EXPANSION & RENOVATE AS NEW – PHASE 1

**CRYSTAL LAKE ELEMENTARY SCHOOL
284 SANDY BEACH ROAD
ELLINGTON, CT 06029
STATE PROJECT NO. 048-0058 EA/RR/PS**

DATE: January 3, 2013

The following changes to the Drawings and Project Specifications shall become a part of the Drawings and Project Specifications; superseding previously issued Drawings and Project Specifications to the extent modified by Addendum No. 4.

RFI # 004

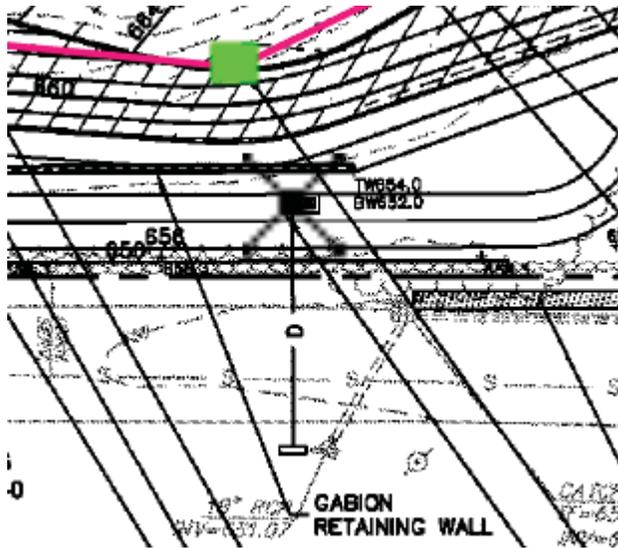
QUESTION: Please clarify the detail for how the 12" HDPE field collector drain will connect to the perforator field drainage and the gravity wall drain on the South side of the property.

Please clarify the slope, concrete head wall design and invert elevation for the 18" RCP outlet of Outlet Control Structure #2 that crosses South Rd.

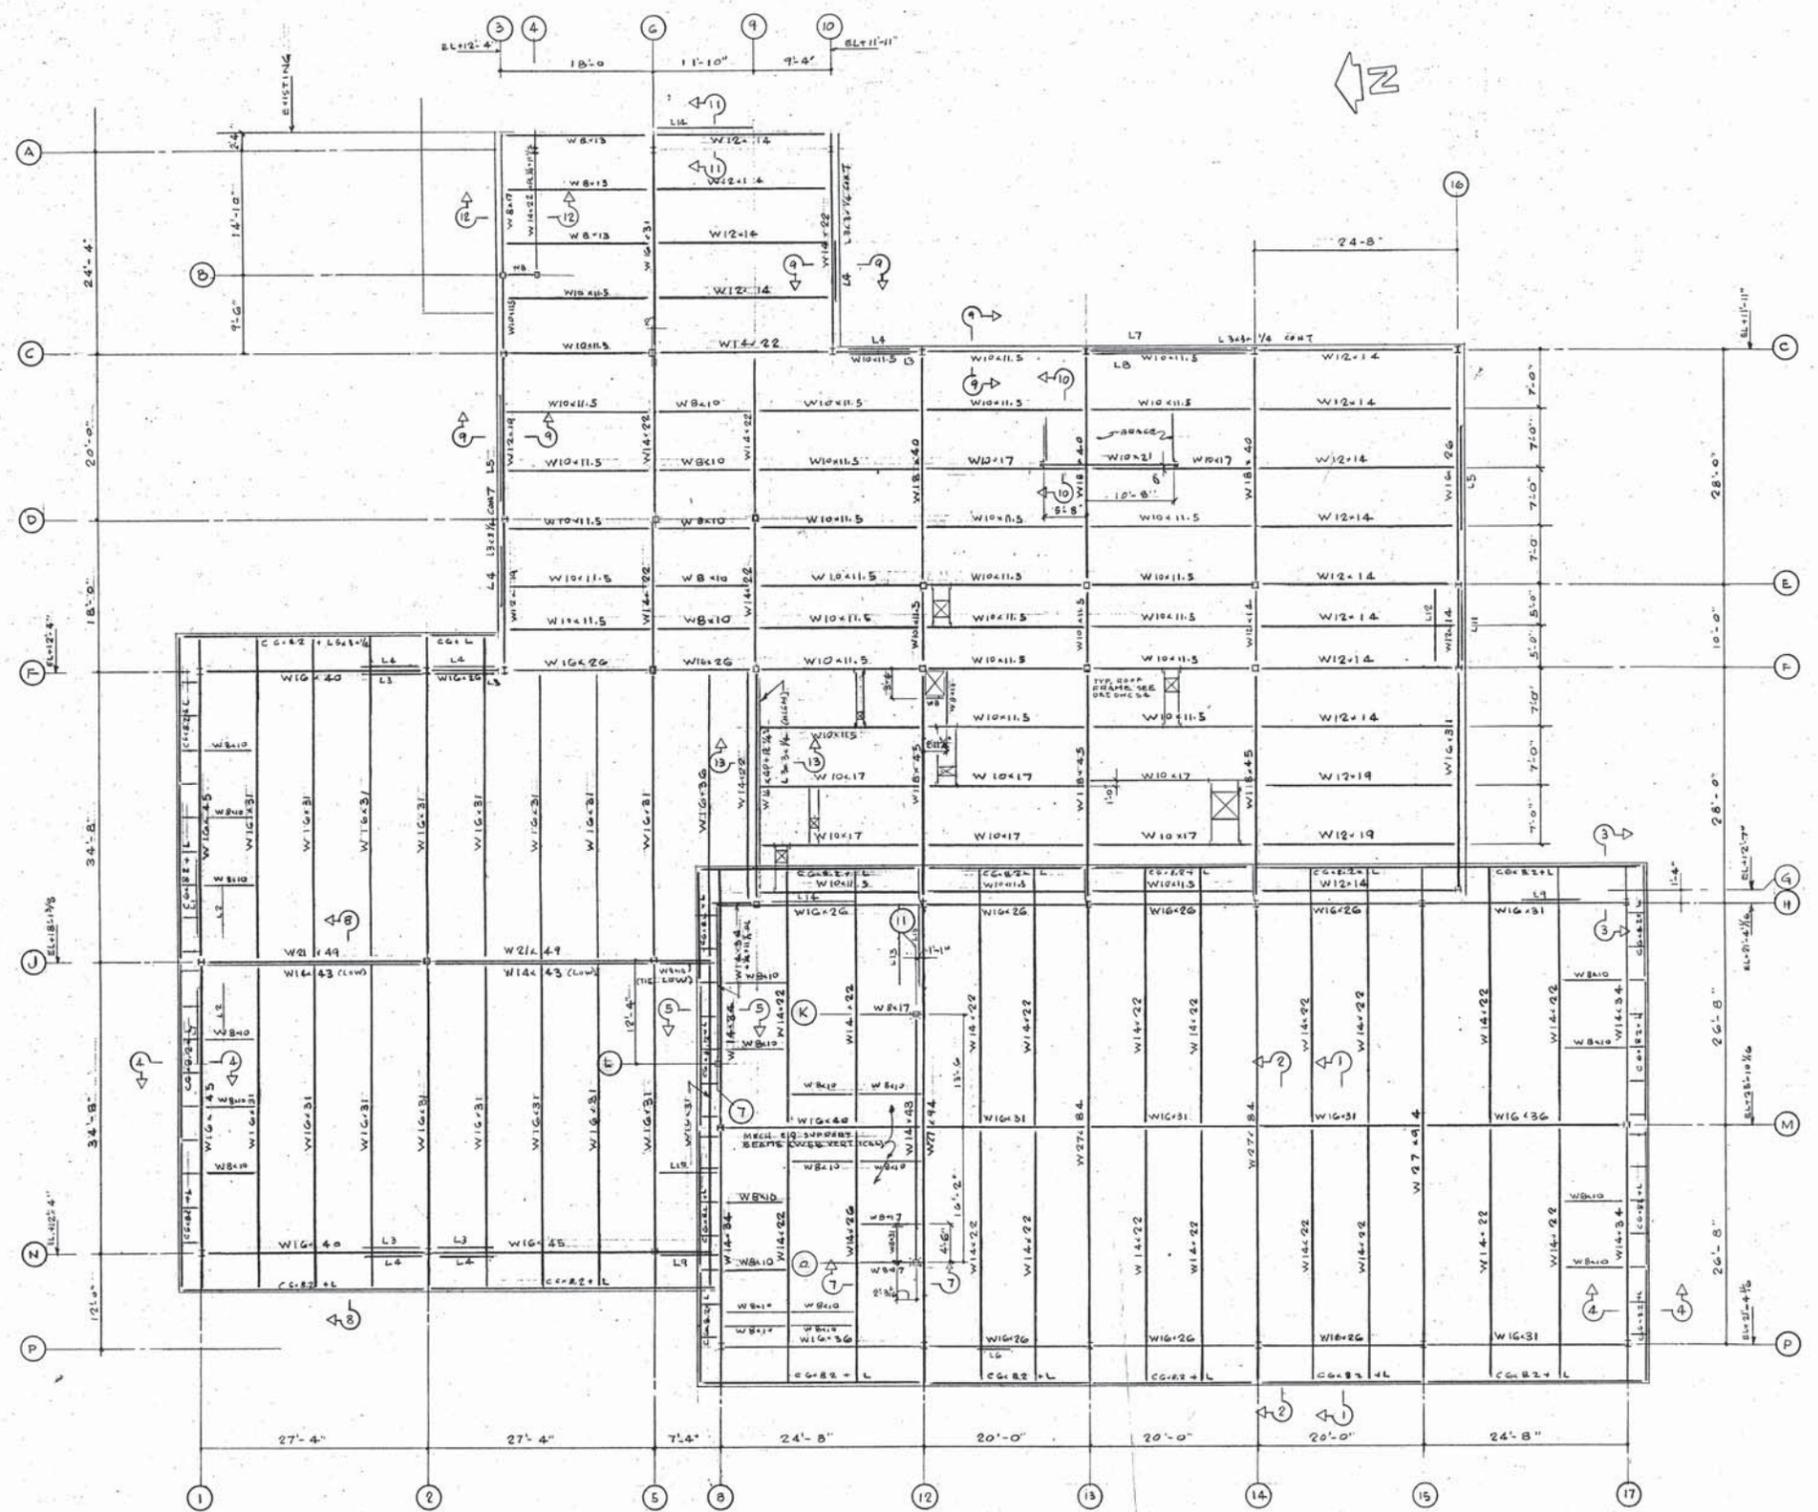
1. Drawing S132 – does the column bay X11/X13 & Xq/Xh have the pair of existing W14 beams like the bay X15/X17 & Xq/Xh? This info needed to determine the additional support required for the overhead supported basketball backboard supports. **Please see attached existing framing plan for the gym area.**
2. Please confirm the gym flooring will continue into the new alcove where the telescoping stands will be installed. **Yes, the gym flooring will continue under the entire telescoping stands.**

RFI # 002

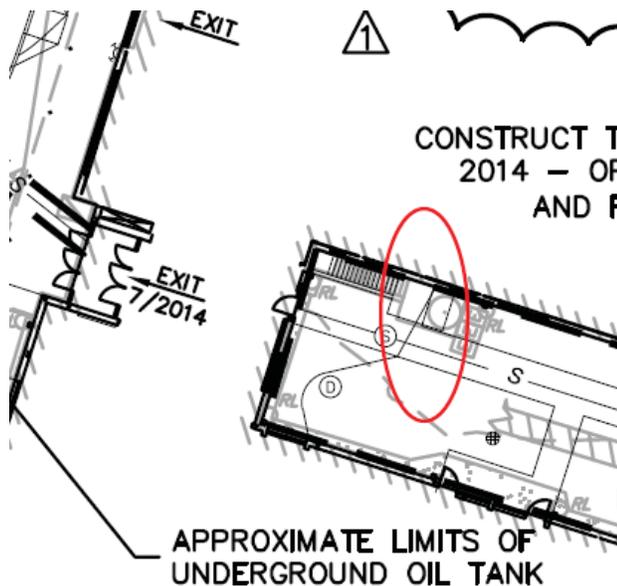
QUESTION: During our site visit today, we noticed an underground water tank located in the small vestibule on the West wall of the basement/boiler room. This water tank is not shown on the site demo drawing C200 or PD 103. It appears this tank will be in conflict with the proposed sanitary installation. See location circled in Red below and photo.

RESPONSE: This tank was *previously* a wellwater storage tank; it was abandoned in place and is not connected to the recently upgraded wellwater supply system. It should be demo'd. Refer to Sketch SKP1, dated 1-3-2014, and related architectural and site Addendum #4 items. MBQ 1-3-2014

CSK-001
REF. SHEET: C-604

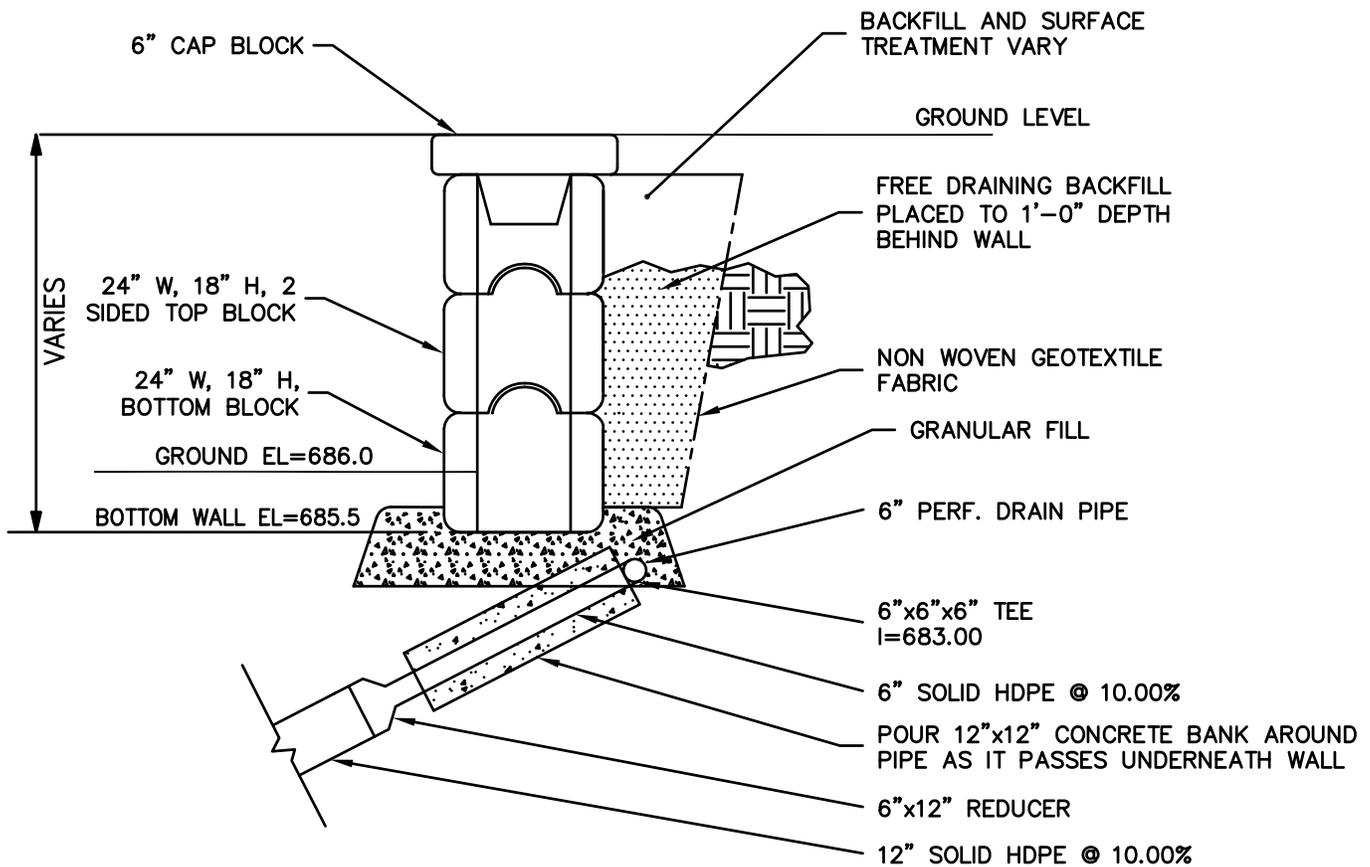
- DRAWING CSK-001, WALL UNDERDRAIN CONNECTION has been added and is attached as part of this addendum. This sketch adds information to Drawing C-604.
- DRAWING CSK-002, DETENTION BASIN OUTLET has been added and is attached as part of this addendum. This sketch revises information on Drawing C-400.

PROJECT #:	12.140	TITLE:	UNDERGROUND WATER TANK REMOVAL	CSK-003
DRAWN BY:	JMC			
CHECKED BY:	WGW			
SCALE:	1"=40'			
DATE:	01/02/14			
ISSUED FOR:	CRYSTAL LAKE ELEMENTARY SCHOOL 284 SANDY BEACH ROAD ELLINGTON, CT. 06029		REF. SHEET: C-200

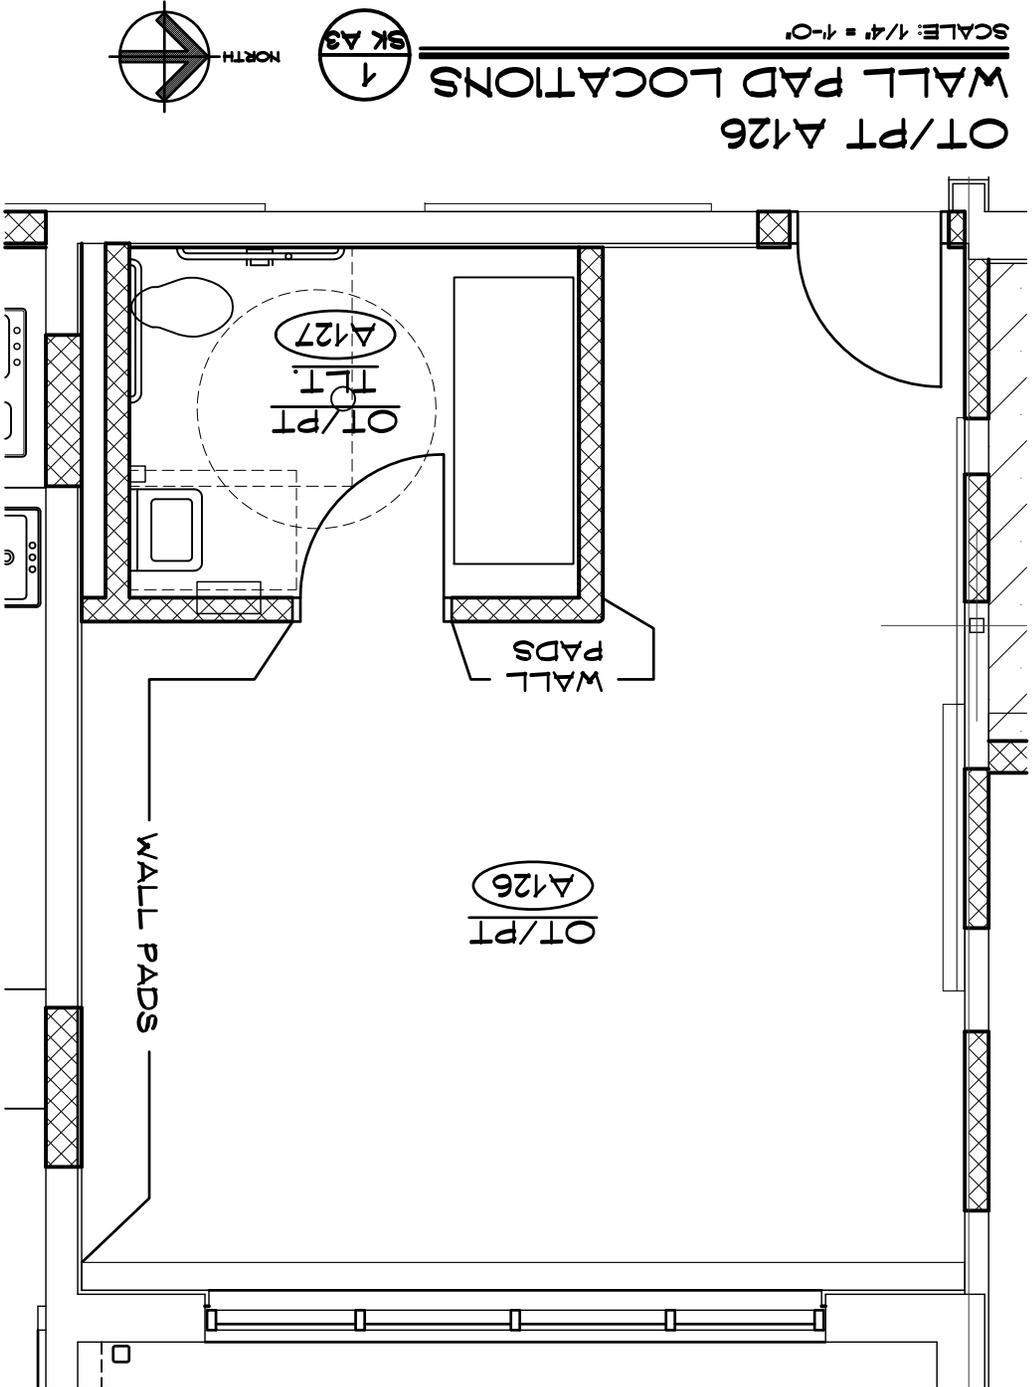
- DRAWING CSK-003, UNDERGROUND WATER TANK REMOVAL has been added and is attached as part of this addendum. This sketch revises information on Drawing C-200.

WATER TANK DEMOLITION NOTES:

1. REMOVE AND PROPERLY DISPOSE EXISTING UNDERGROUND WATER TANK.
2. PROTECT ADJACENT CONCRETE FOUNDATION AND SLAB.
3. ANY DAMAGE TO FOUNDATION AND/OR SLAB SHALL BE REPAIRED BY THE CONTRACTOR, IN KIND, AT NO ADDITIONAL COST TO THE OWNER.

Drawing Title:
PT / OT Wall
Pads

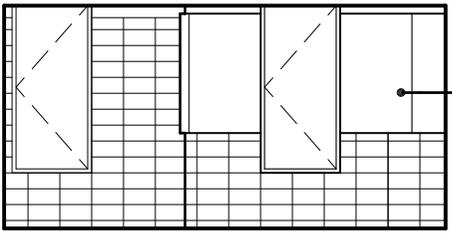
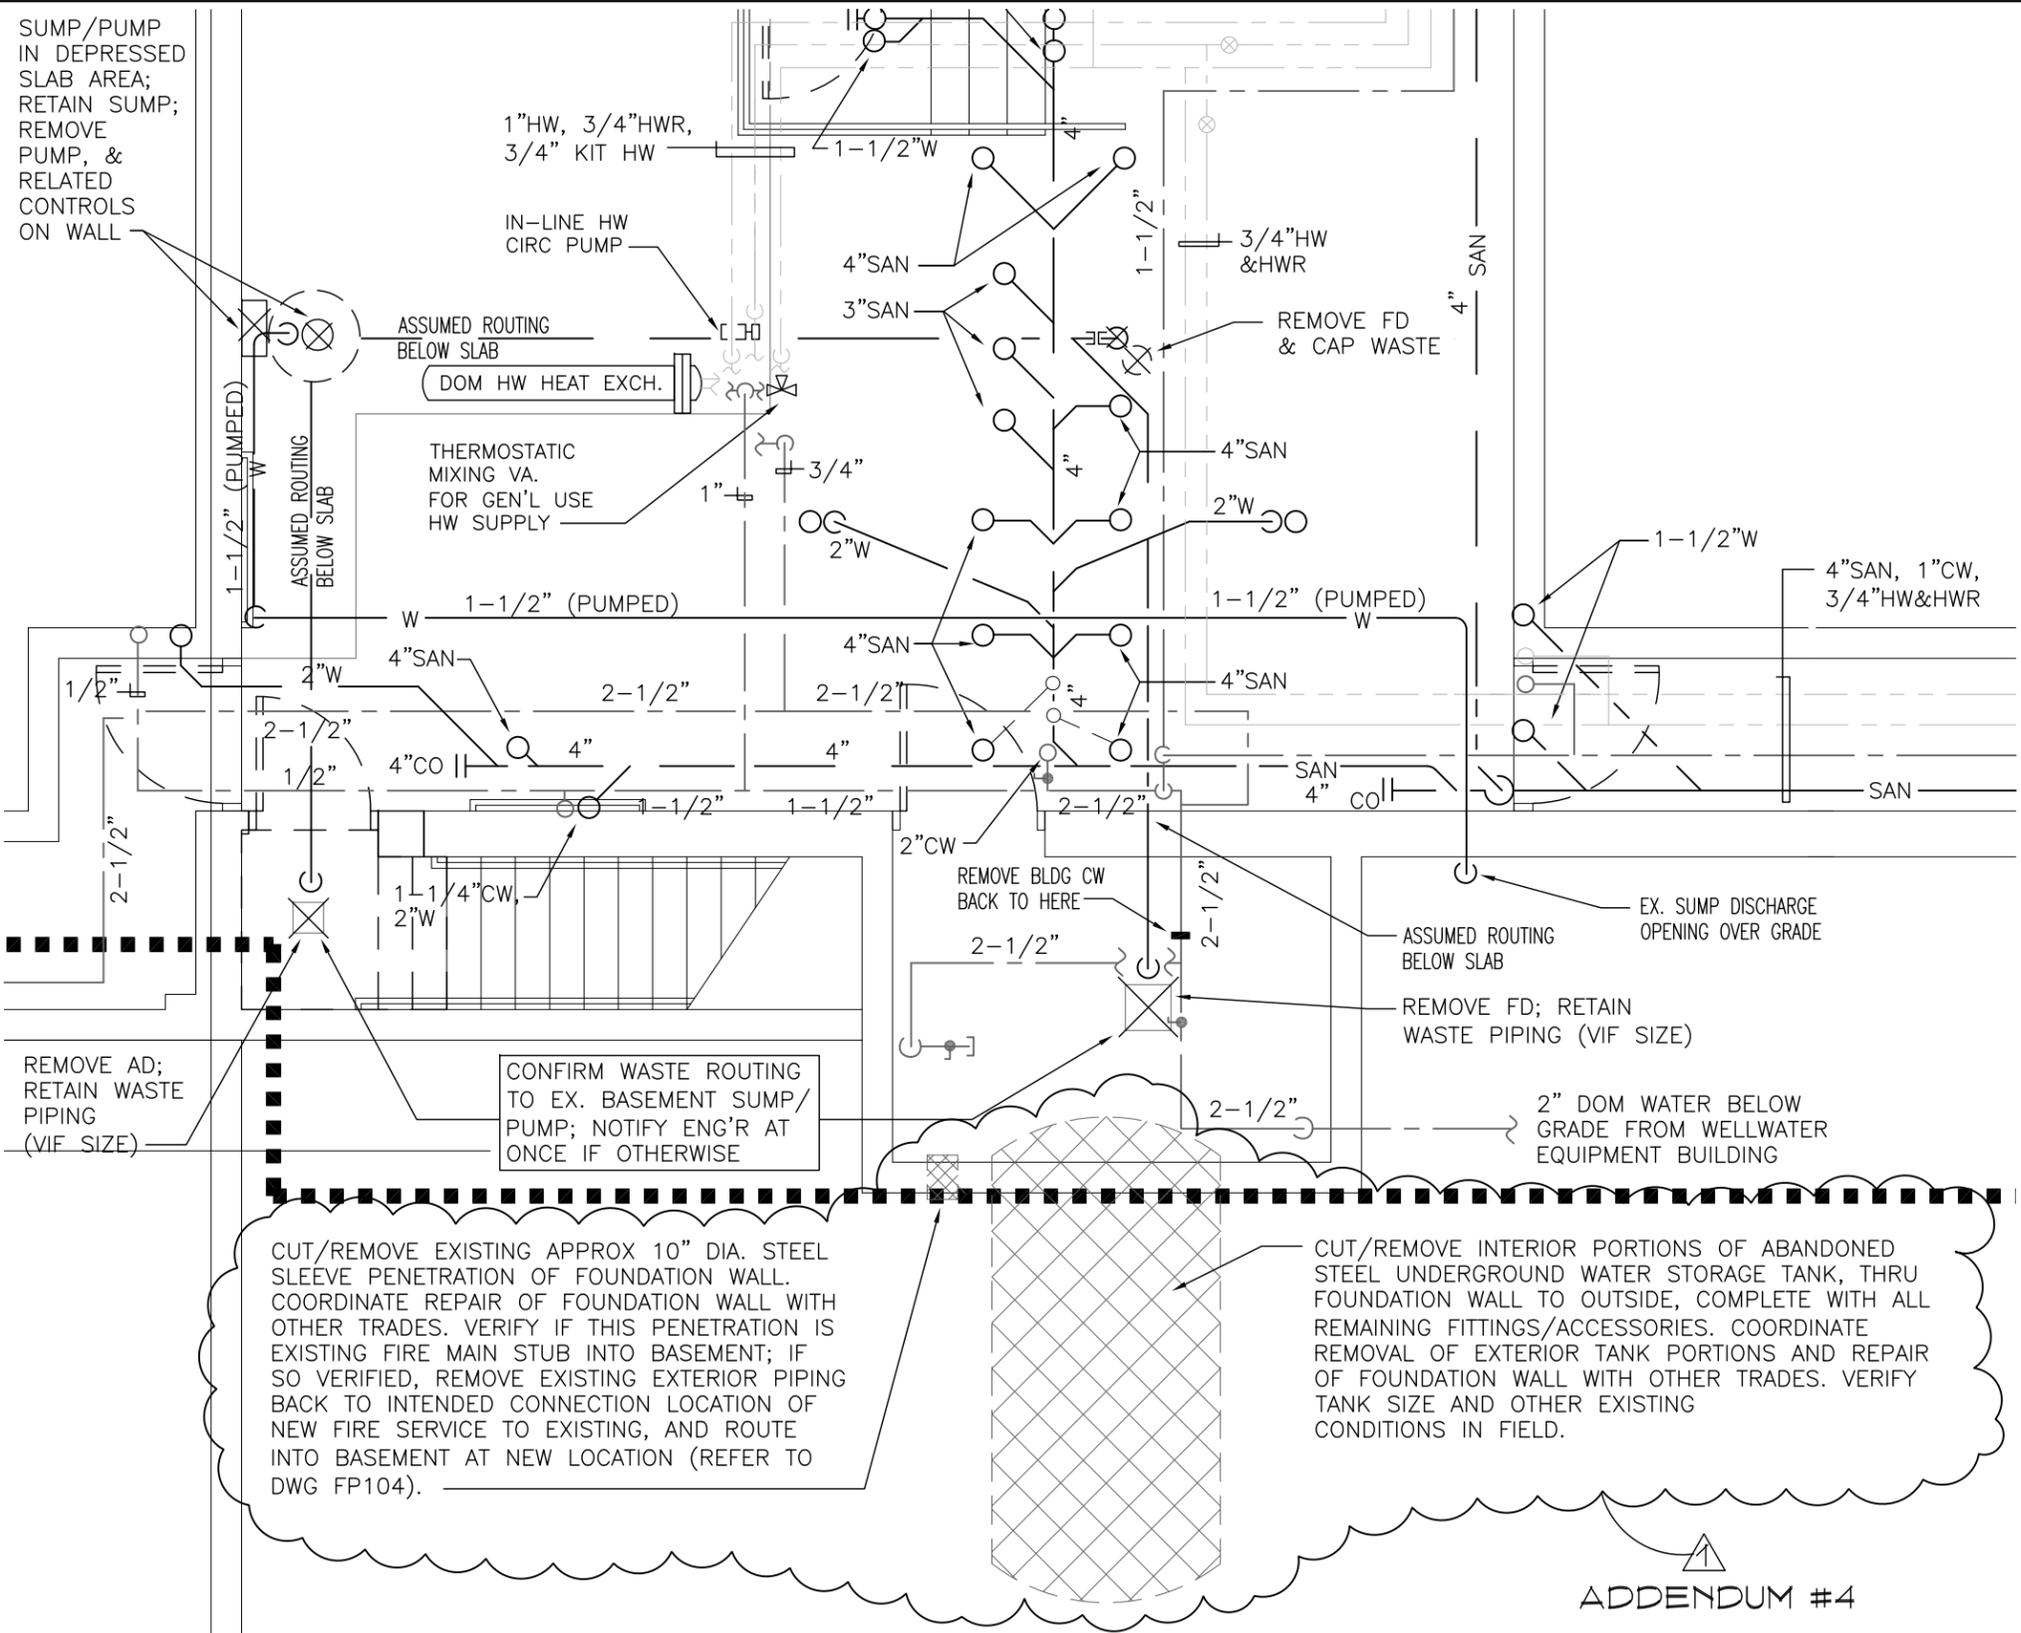
- DRAWING SKA3, PT/OT WALL PADS has been added and is attached as part of this addendum. This sketch clarifies information on Drawing A723.
- DRAWING SKP1, REMOVE BURIED TANK & FOUNDATION WALL PENETRATION has been added and is attached as part of this addendum. This sketch revises information on Drawing PD103.~

**NEW WALL PADS:
COORDINATE PUNCHED
AREAS/TRIM NEEDED FOR
SWITCHES AND OTHER WALL
MOUNTED OBSTACLES; SEE
PROJECT MANUAL**

Project Number: 12-140
Drawing Title: REMOVE BURIED TANK AND FOUNDATION WALL PENETRATION
Drawing Number: 1-3-2014 (ADD #4)
Drawing Scale: 1/8" = 1'-0"
Drawing By: MBG

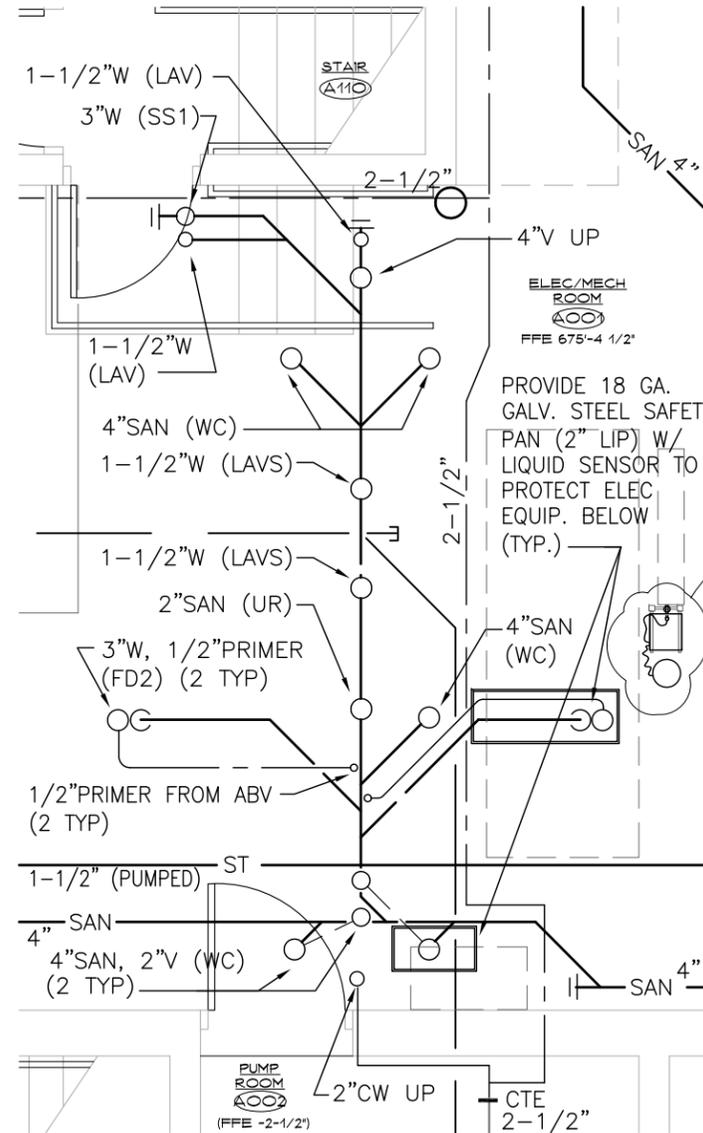
CUT/REMOVE EXISTING APPROX 10" DIA. STEEL SLEEVE PENETRATION OF FOUNDATION WALL. COORDINATE REPAIR OF FOUNDATION WALL WITH OTHER TRADES. VERIFY IF THIS PENETRATION IS EXISTING FIRE MAIN STUB INTO BASEMENT; IF SO VERIFIED, REMOVE EXISTING EXTERIOR PIPING BACK TO INTENDED CONNECTION LOCATION OF NEW FIRE SERVICE TO EXISTING, AND ROUTE INTO BASEMENT AT NEW LOCATION (REFER TO DWG FP104).

THIS SKETCH MODIFIES A PORTION OF DRAWING PD103
